Madison Heights - 11 Mile Streetscape - NFE Job N753

F&V Comments, December 18, 2023

TABLE R211 ON-STREET PARKING SPACES

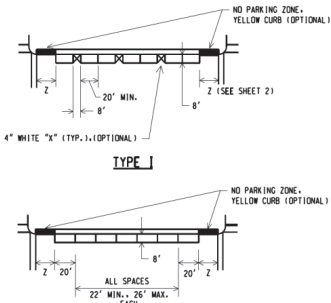
- You'll need to add ADA parking per PROWAG requirements. The number of spaces required is based upon the "block perimeter". Since there is no commercial parking on the adjacent streets, you'll need to add one ADA parking space per block, per side of the road.
